Access Compliance Report Public Rights-of-Way (Curb Ramps)

Main Street: WYETH_ST Cross Street: ARTISAN_ST Location: N

ADA ID: RPRK211020164842 Ramp Type: Type 4 - Parallel Initial Pass/Fail: Fail Overall Compliance: No Severity Score: 15

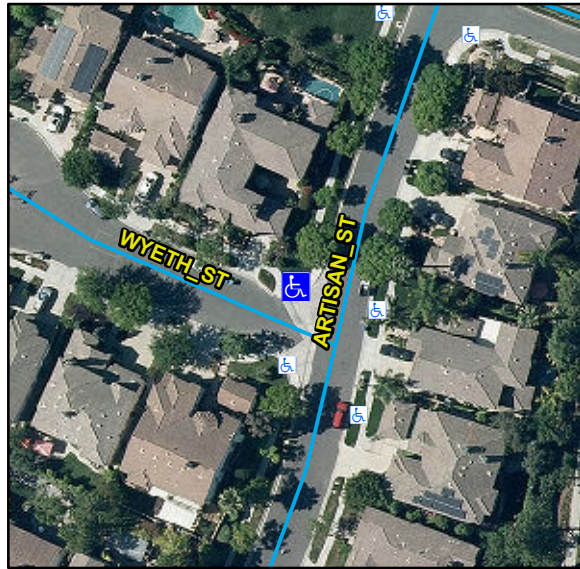
Compliance	Description	Data	Compliance	Description	Data
N/A	Ramp Length LT (in)	106	N/A	Ramp Length RT (in)	118
Yes	Ramp Width LT (in)	53	Yes	Ramp Width RT (in)	53
Yes	Ramp Run Slope LT (%)	3.9	No	Ramp Run Slope RT (%)	10.7
Yes	Ramp Cross Slope LT (%)	0.9	Yes	Ramp Cross Slope RT (%)	1.1
N/A	Landing Present	N/A	N/A	DWS Provided	N/A
N/A	Landing Length (in)	N/A	N/A	DWS Contrast	N/A
N/A	Landing Width (in)	N/A	N/A	DWS Length (in)	N/A
N/A	Landing Run Slope (%)	N/A	N/A	DWS Full Width	N/A
N/A	Landing Cross Slope (%)	N/A		DWS Offset Type	N/A
N/A	Landing Movement Obstructed?	N/A	N/A	DWS Offset Left (in)	N/A
	Landing Movement Type	N/A	N/A	DWS Offset Right (in)	N/A
N/A	Landing Shared	N/A			
N/A	Clear Space	Yes			
N/A	Clear Space To Crosswalk (in)	N/A			
N/A	Marked Crosswalk 1	No	N/A	Marked Crosswalk 2	No
	Crossing 1 Direction	SW		Crossing 2 Direction	SE
	Marked Crosswalk 1 Width (in)	N/A		Marked Crosswalk 2 Width (in)	N/A

Remove & Replace Curb Ramp With Two New Directional Ramps or Equivalent.
